Addendum No.: 2

Bid#: 24-63-2

Project Name: Lacombe Trace Trails and Nature Park

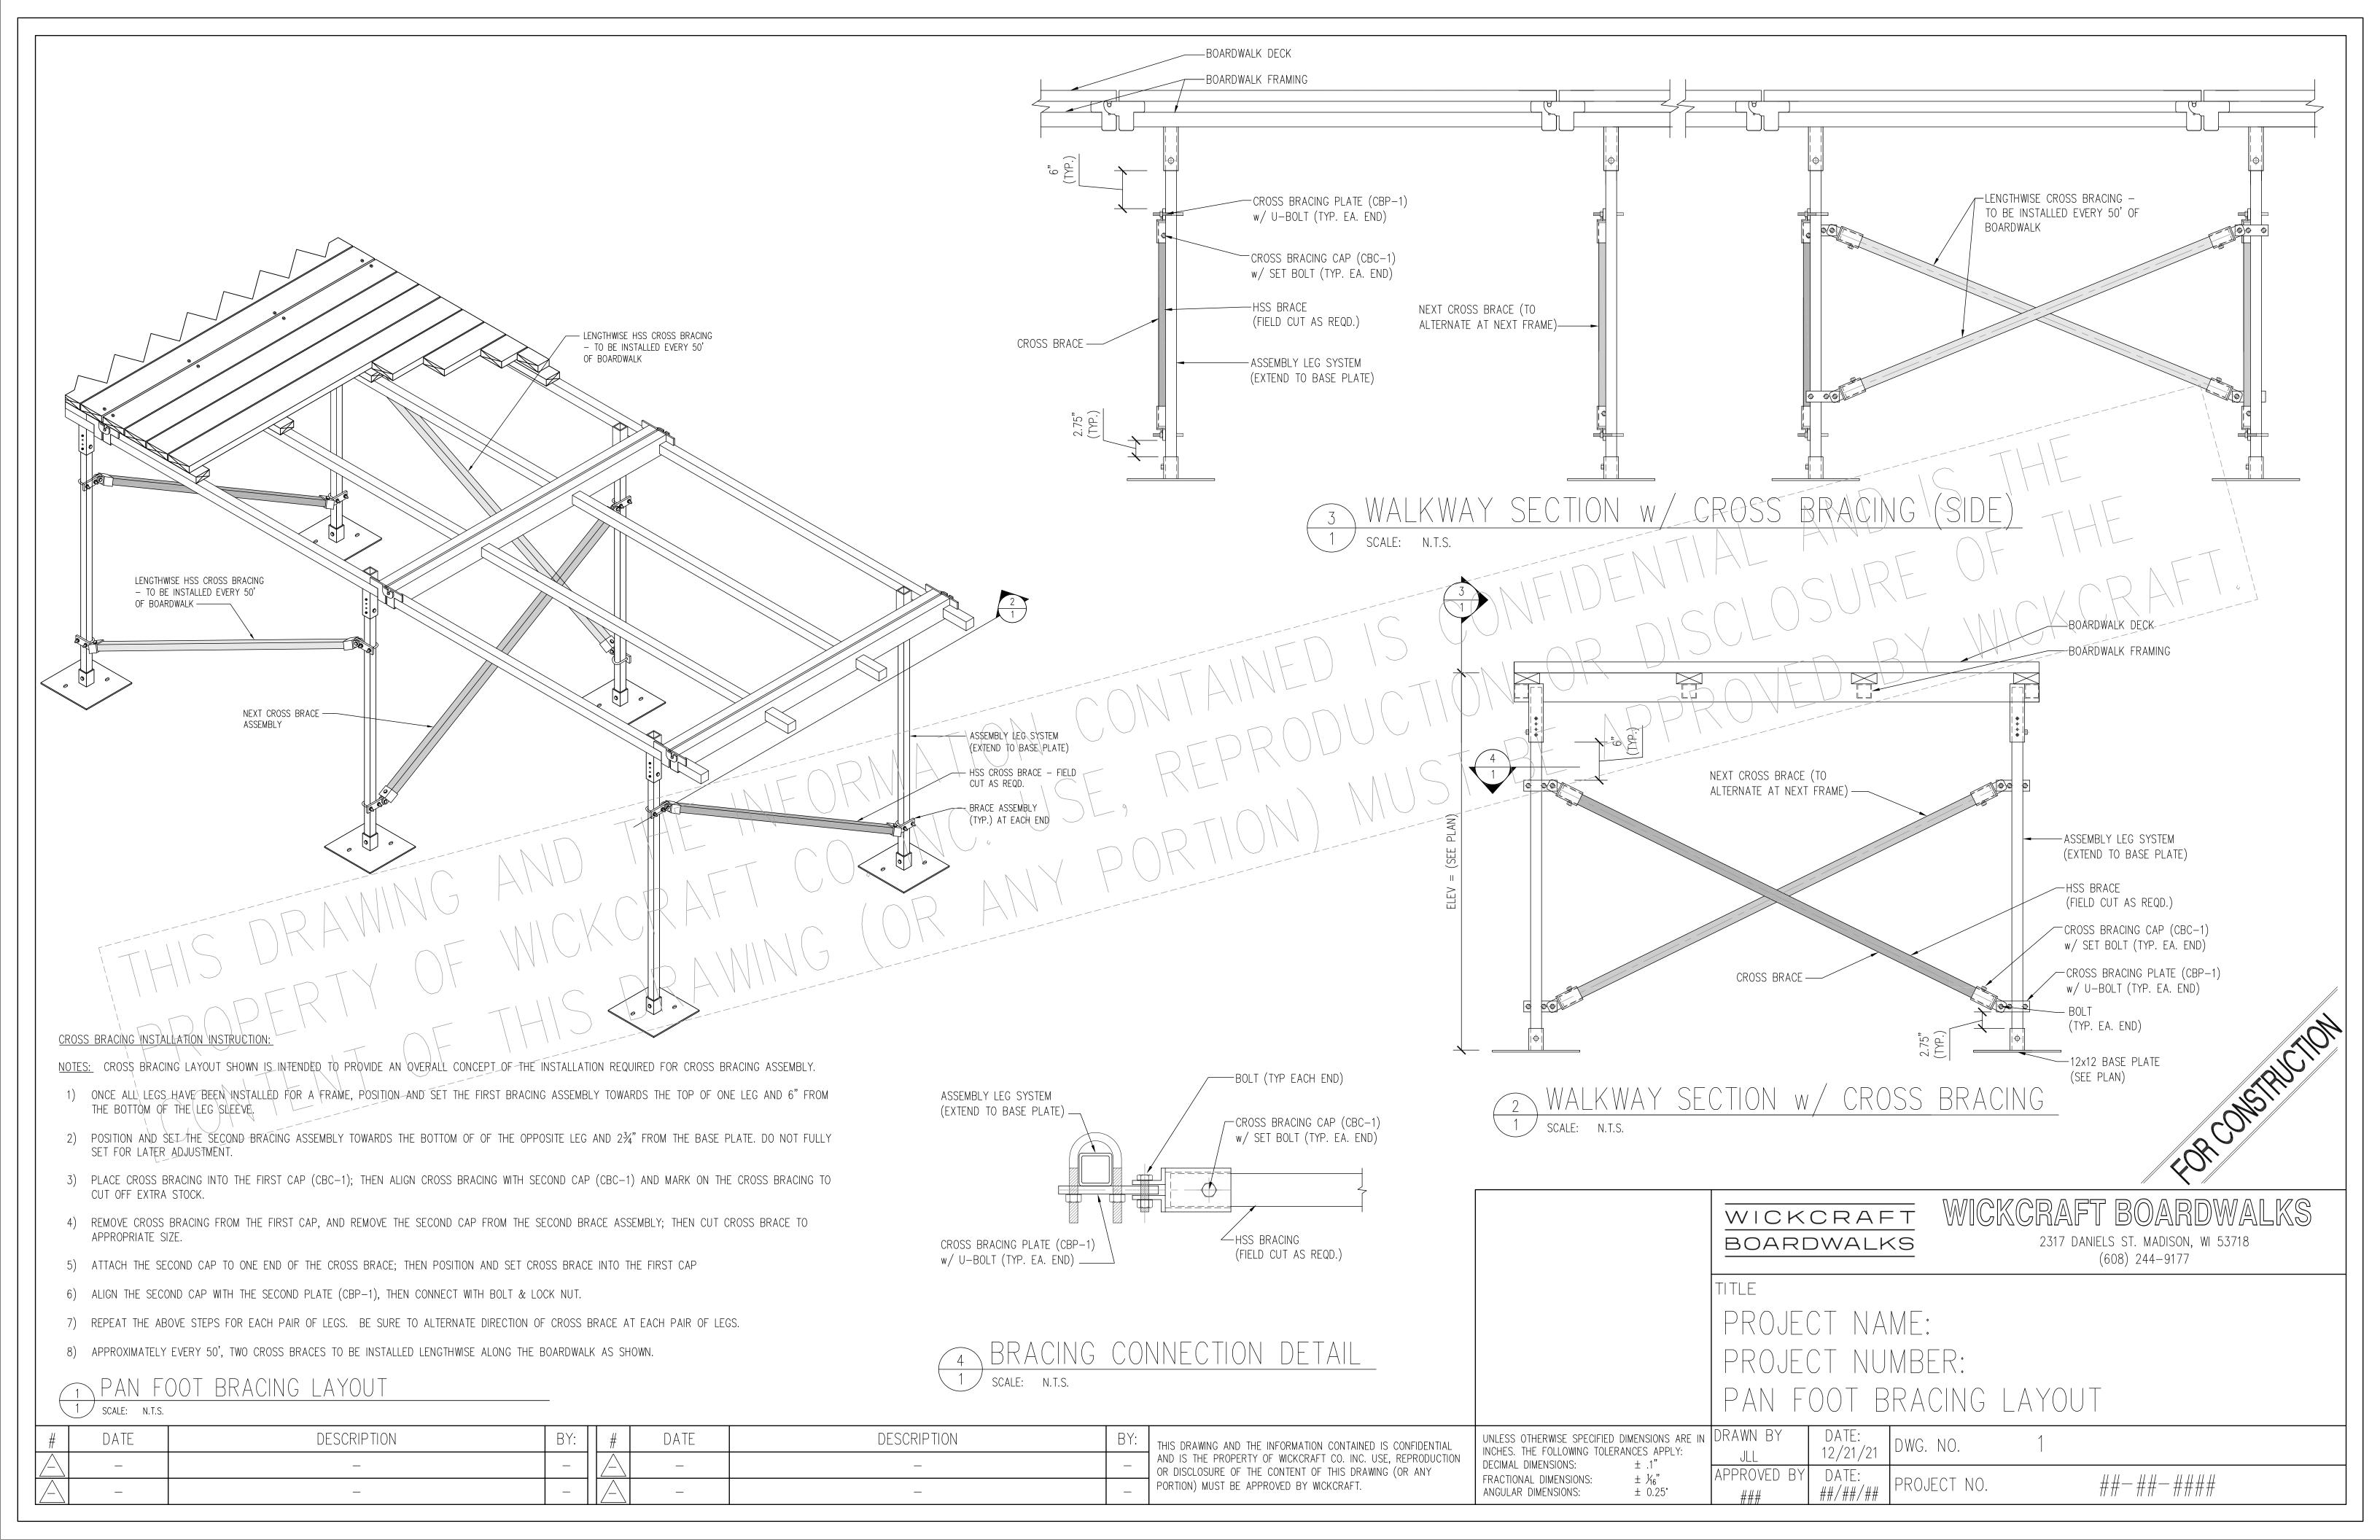
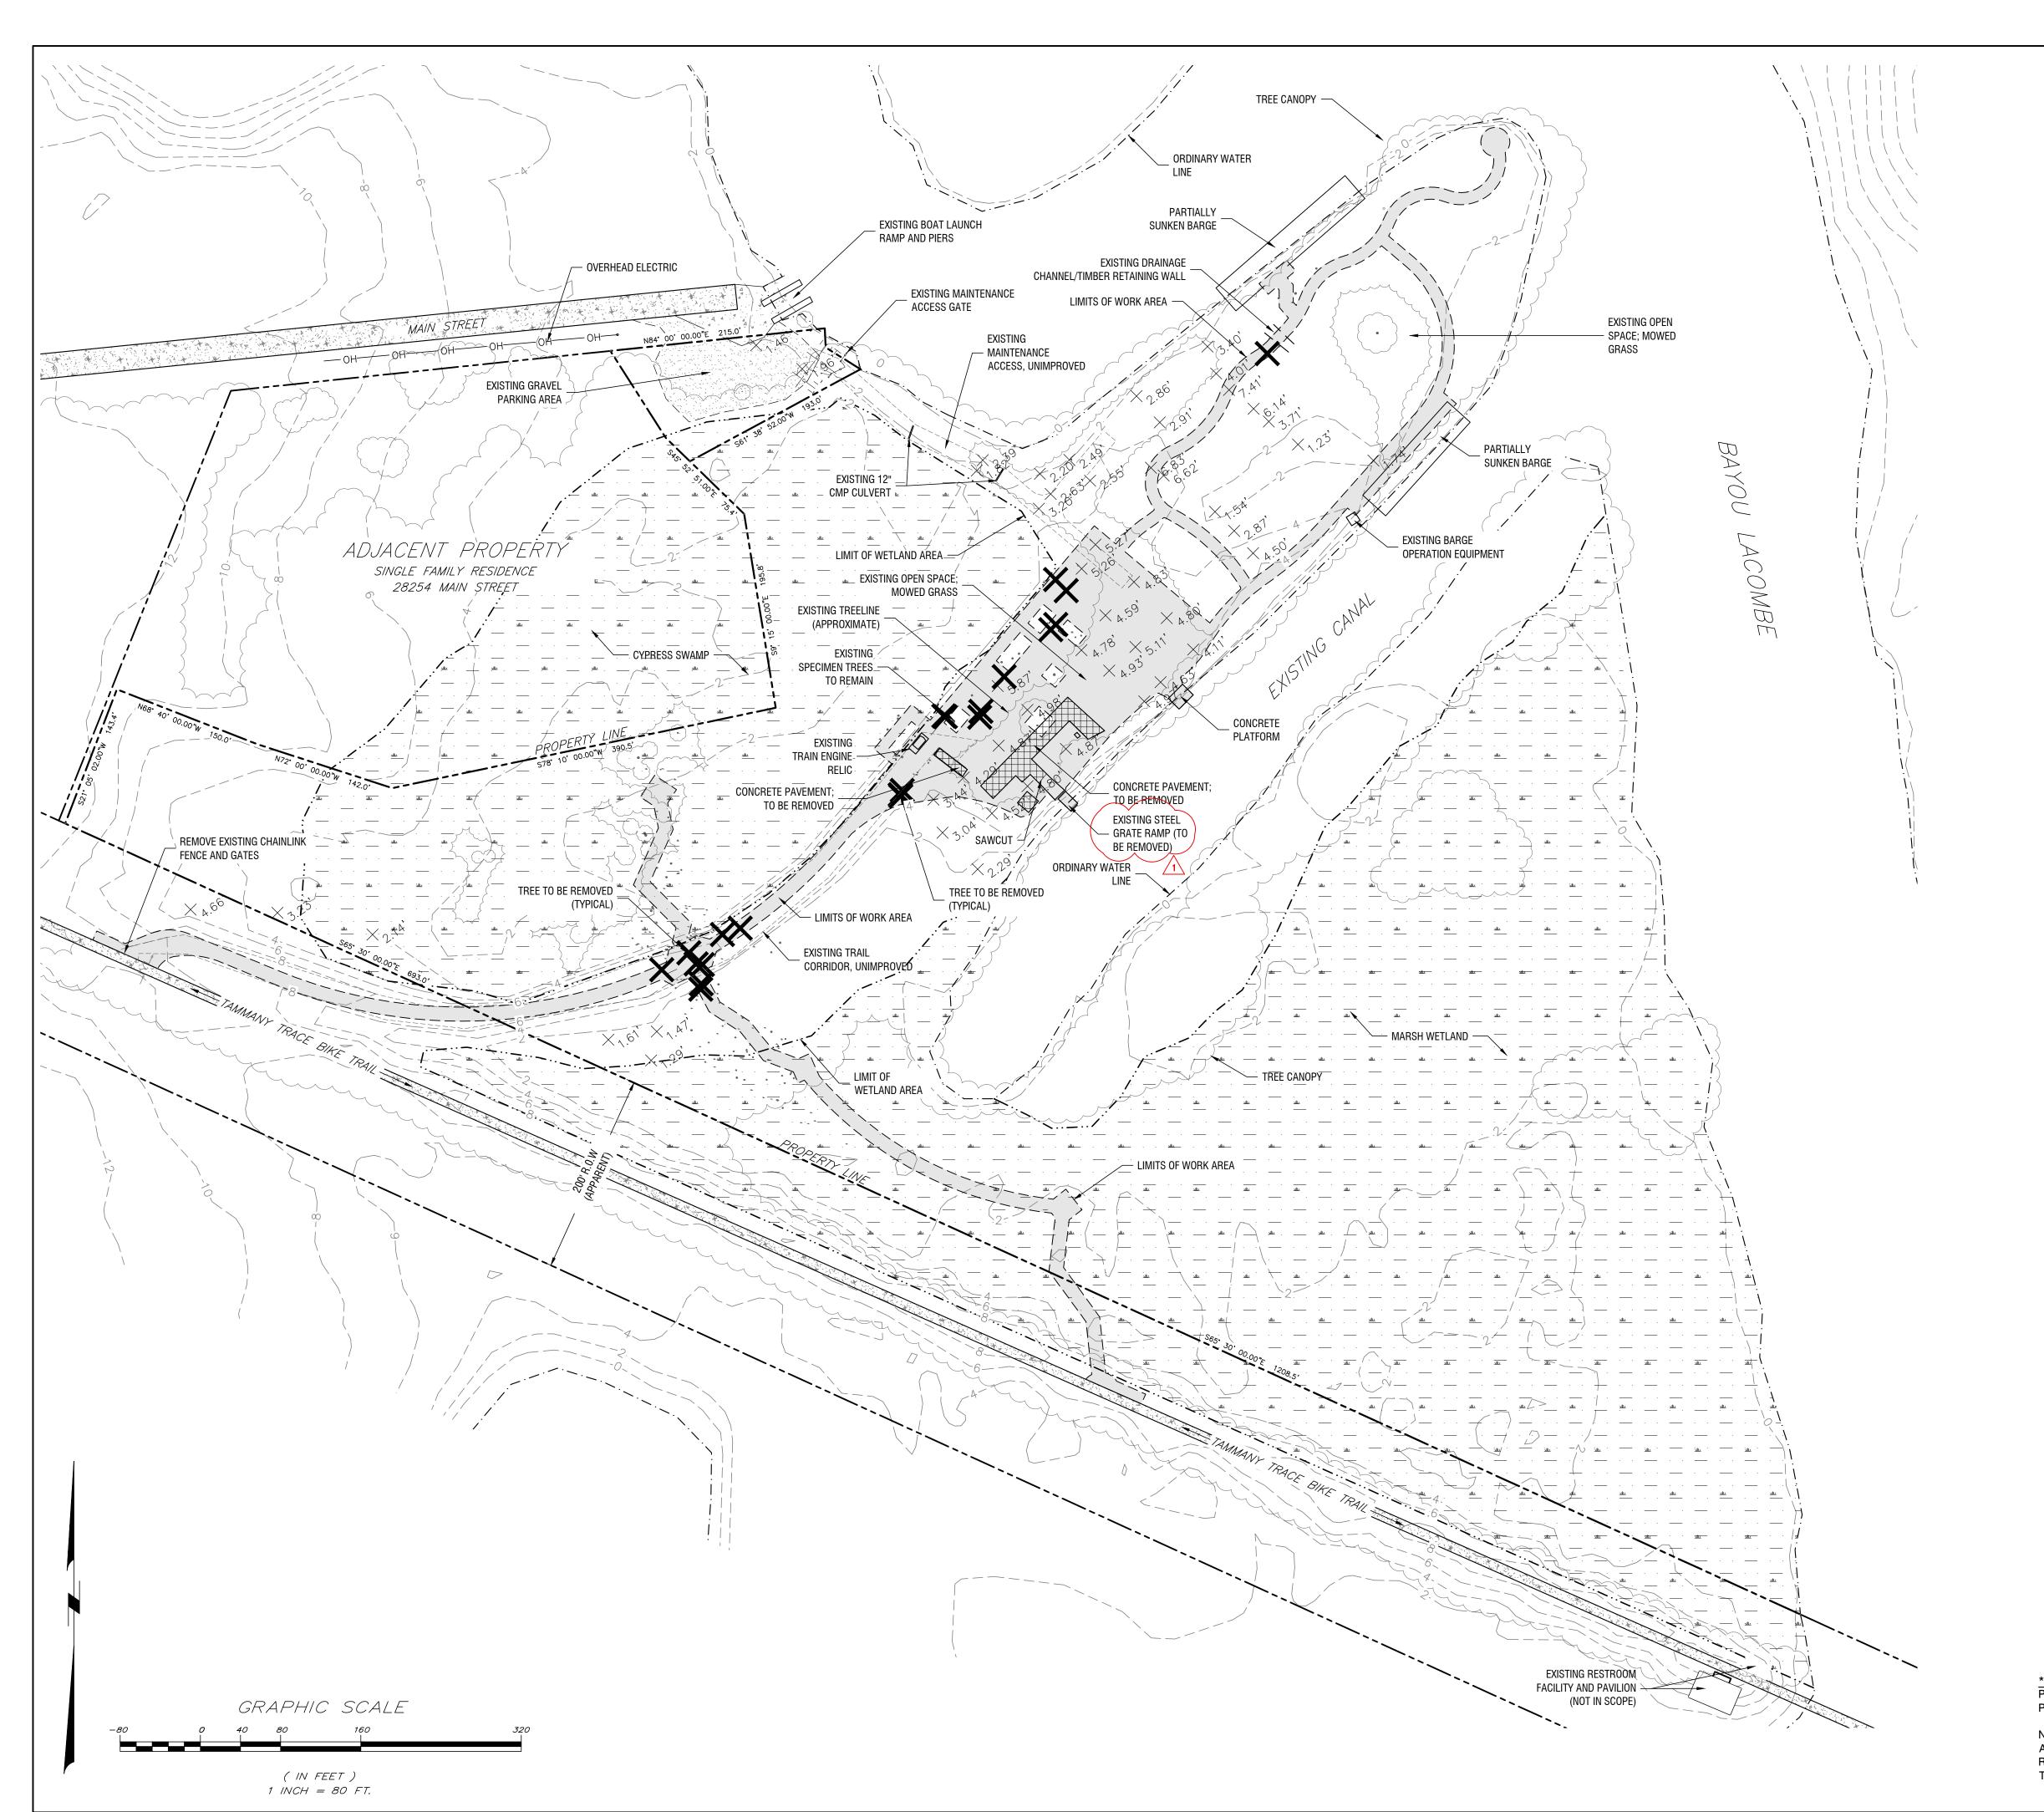
Pertaining to Boardwalk Installation - In addition to standard boardwalk framing as shown on detail sheet L5.4, cross bracing will be supplied and is to be installed per attached manufacturer details for boardwalk sections where the walking surface greater than 30" above grade. There are a total of 63 bracing sets to be included in the installation package. Actual site conditions may warrant small adjustments in total quantity. See attached "Pan Foot Bracing" detail for more information.
